Project: Department of Infrastructure, Planning and Logistics – Mandorah Marine Facilities **Project No:** 304700560
To: Suzanne Dunkerton **Date:** 22/06/2023
From: Amber Evans

RE: Response to NT EPA direction to provide additional information to the SER

Table 1. Additional information to be provided in accordance with Regulation 124. Black font represents Stantec's responses to the EPA's Direction to Provide Additional Information on the 16 May 2023; green font represents Stantec's responses and/or clarifications to the EPA's questions following a meeting between Stantec, DIPL and EPA on 8 June 2023.

Attachment 3 Proposed Site Plan

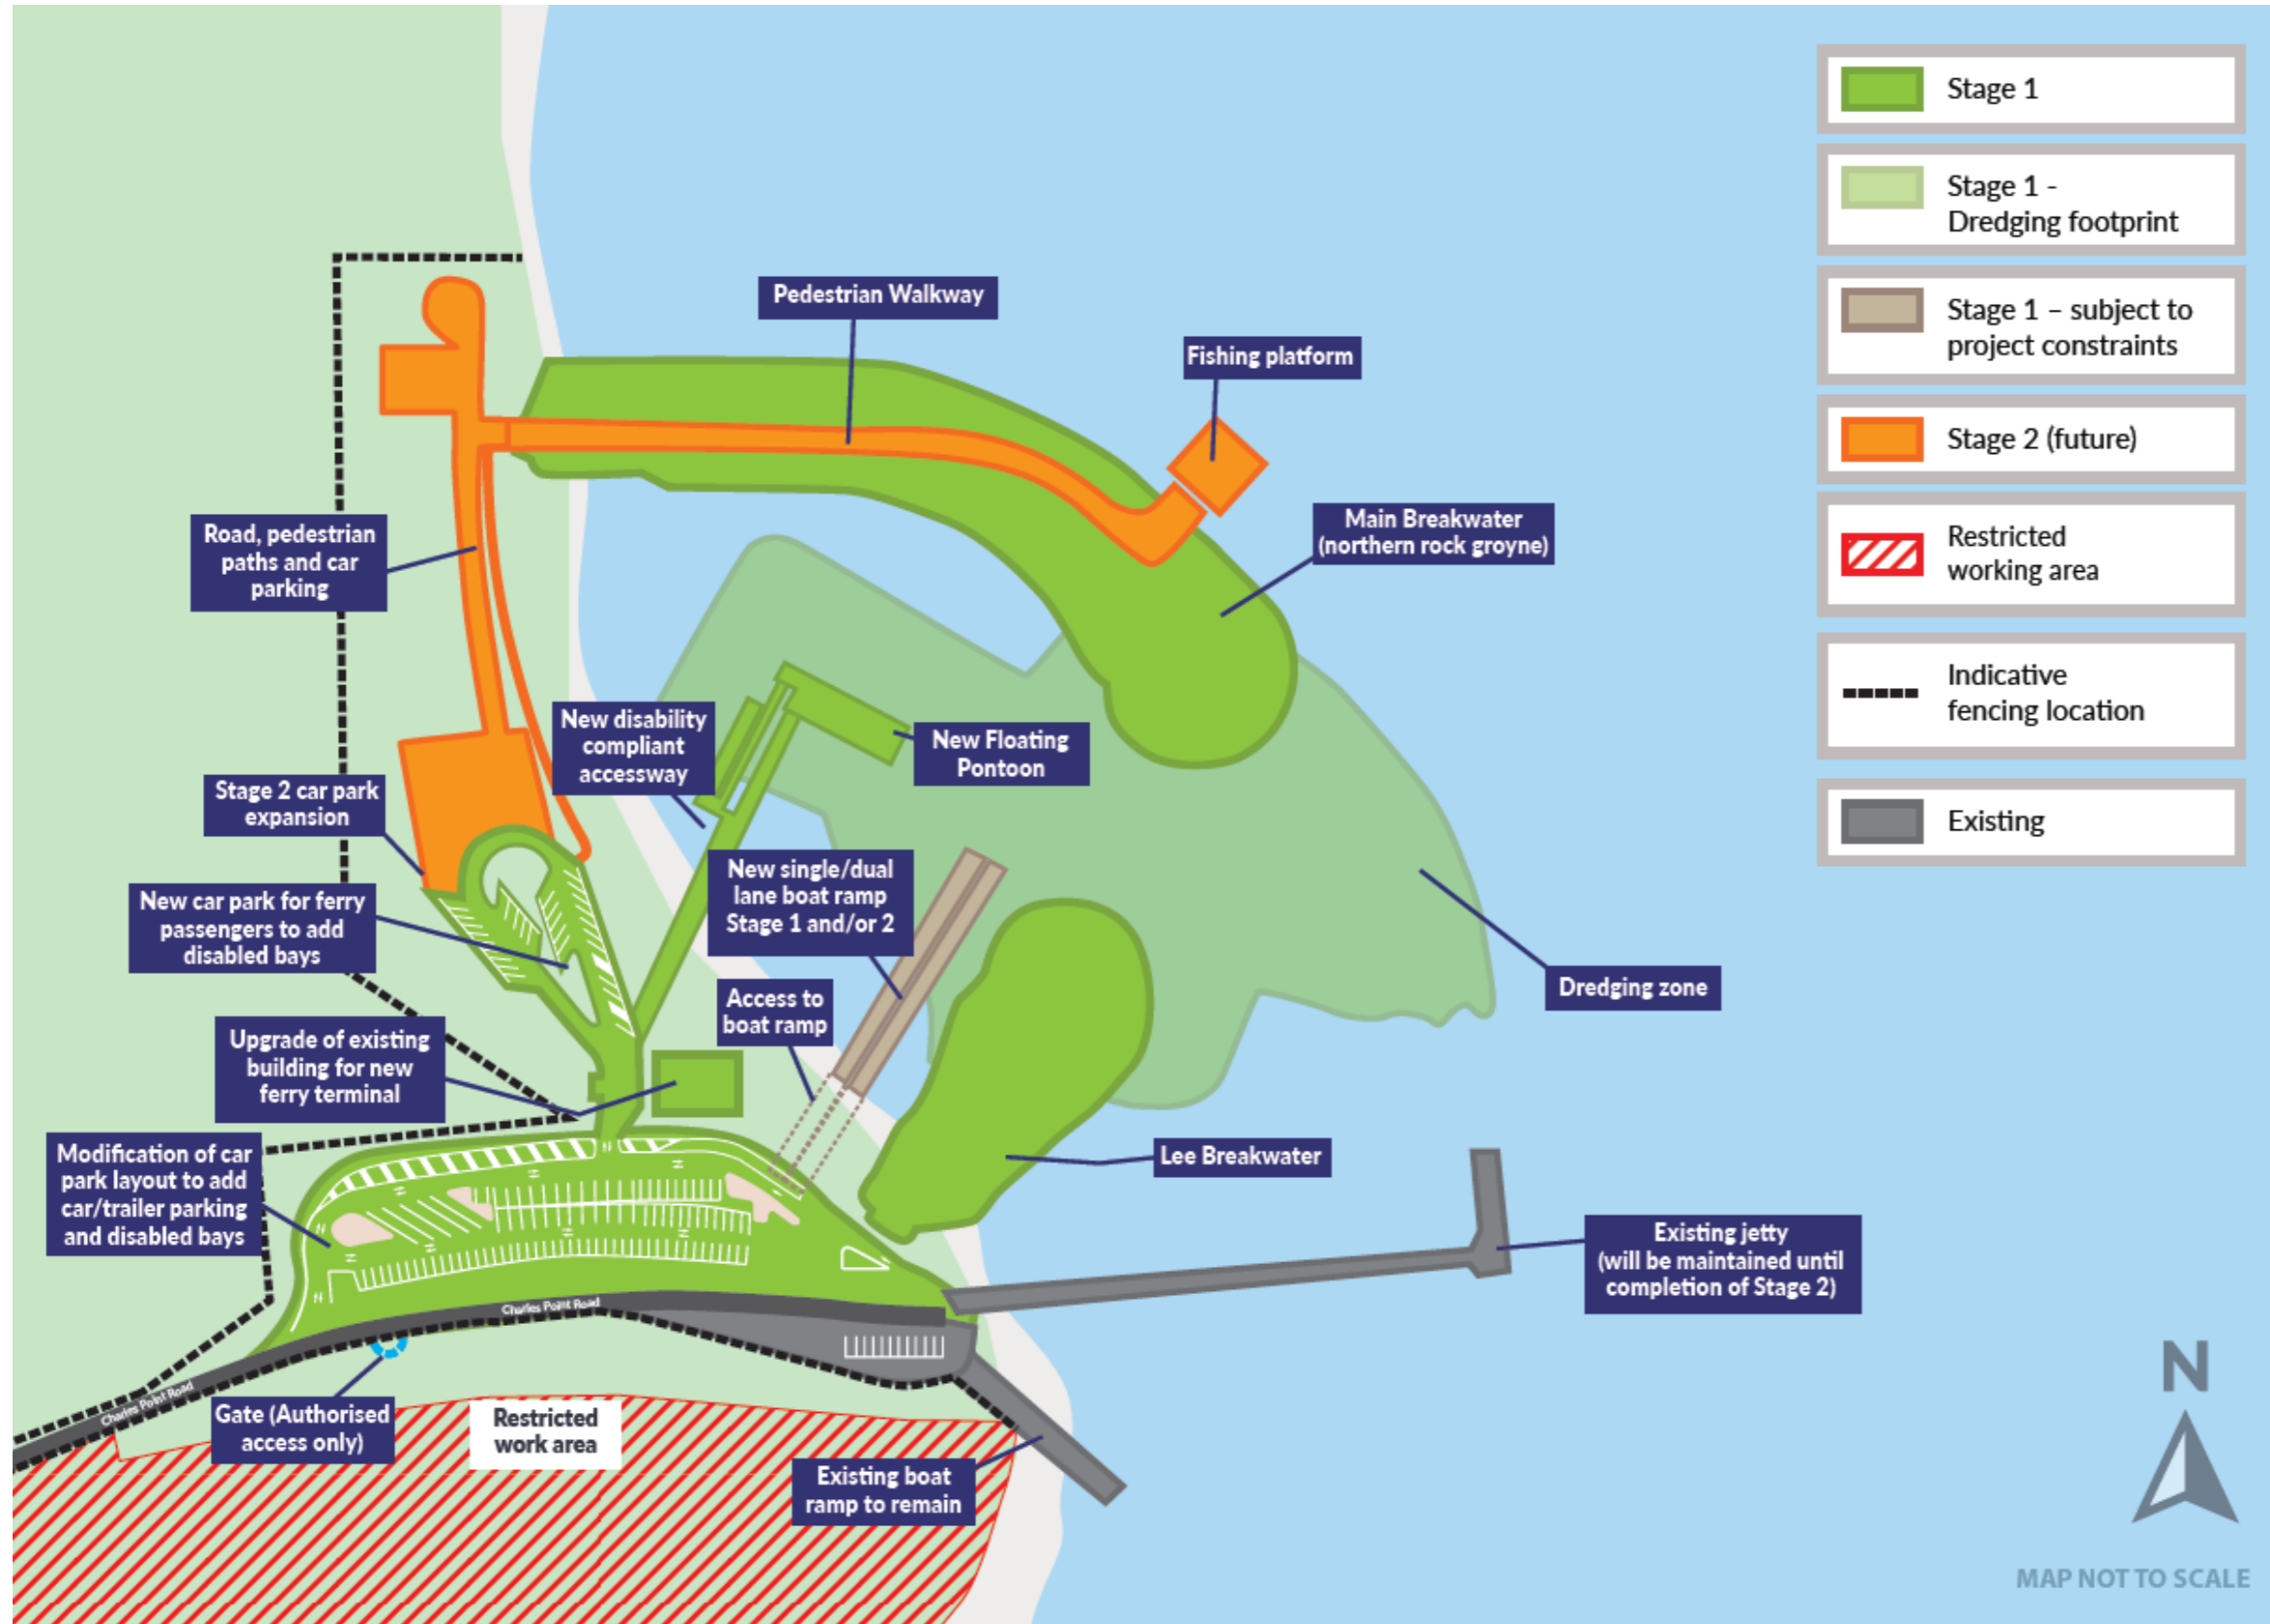
Item #	Context	Additional Information Required	Response
1	<p>Extent of the proposed action</p> <p>There is no succinct summary of the extent of proposed actions to be delivered in Stage 2, including construction of a fishing platform and extension of the access road and car parking established over Stage 1.</p>	<ol style="list-style-type: none"> Provide a table summarising the maximum extent of each proposal element to be delivered in Stage 1 and Stage 2, and the total maximum extent of the whole proposed action. Provide spatial files for proposed Stage 2 works in an appropriate format (such as, kml, kmz, shp) 	<p>The infrastructure footprint provided with the SER shows the extent of all developments proposed under this referral. This shapefile is contained in data folder: 20230224_mandorah_data_delivery provided to the EPA for inclusion with the SER.</p> <p>It was determined during the concept design phase that a fishing platform and additional car parking would not be included in this project and flagged that a second stage of the project is planned and may include:</p> <ol style="list-style-type: none"> A fishing platform built on the breakwater including a pedestrian walkway from the land (to replace the existing Mandorah Jetty at the end of its structural life); Extension of the access road to reach the pedestrian walkway and additional car parking, including car parking for ferry passengers and bays for the disabled; and The addition of a second lane to upgrade to a dual lane boat ramp, which may meet the roll on-roll off needs into the future. <p>There is no exact extent for this and it would be completed under a separate referral. An approximate extent is provided in the attached concept site plan (Attachment 3).</p>
